## DRAWING TECHNICAL NOTICE

DRAWING NO. 6805ABE200	SUFFIX	REV LTR <b>B</b>
DRAWING TITLE Computer Assembly, IOS Computer		SHEET <b>1</b> OF <b>8</b>

CHANGE CLASS		APPROVALS SEE TSSC TSCO NO.
I		<b>ECP 153</b>
II	X

I/DTN NO. T0001

Drawing Sheet 4  
See image below

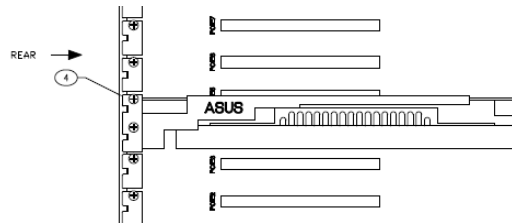
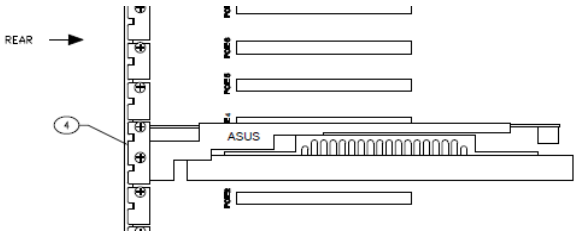
The parts specified in the contract for the IOS update were obsolete at the time of contract award.  
Sheet 1 of 2.

FN 1  
Part: 262-500002008-00; Nom: Chassis, PCI Bus, 15 Slot

FN 2  
Cage: Blank; Part: SN-208FB/BEDE; Material: Samsung

FN 3  
Part: ST310005N1A1AS-RK

FN 4  
Part: GTX 650TI

FN 7  
Part: GLC-00182; Nom: Windows 7 Ultimate, 64 Bit

FN 8  
Part: 4006; Nom: NFS Server for Windows

- FN 1  
Part: 262-500002310-00; Nom: Chassis, 4U, 15 Slot
- FN 2  
Cage: SL151; Part: GTCON; Material: LG Electronics
- FN 3  
Part: ST1000DM003
- FN 4  
Part: GTX 750TI

- FN 7  
Part: 261500001097-00; Nom: Windows 10 Enterprise 2016, LTSC, 32 Bit
- FN 8  
Part: 4021; Part: NFS Server for Windows Ver 6.3.3
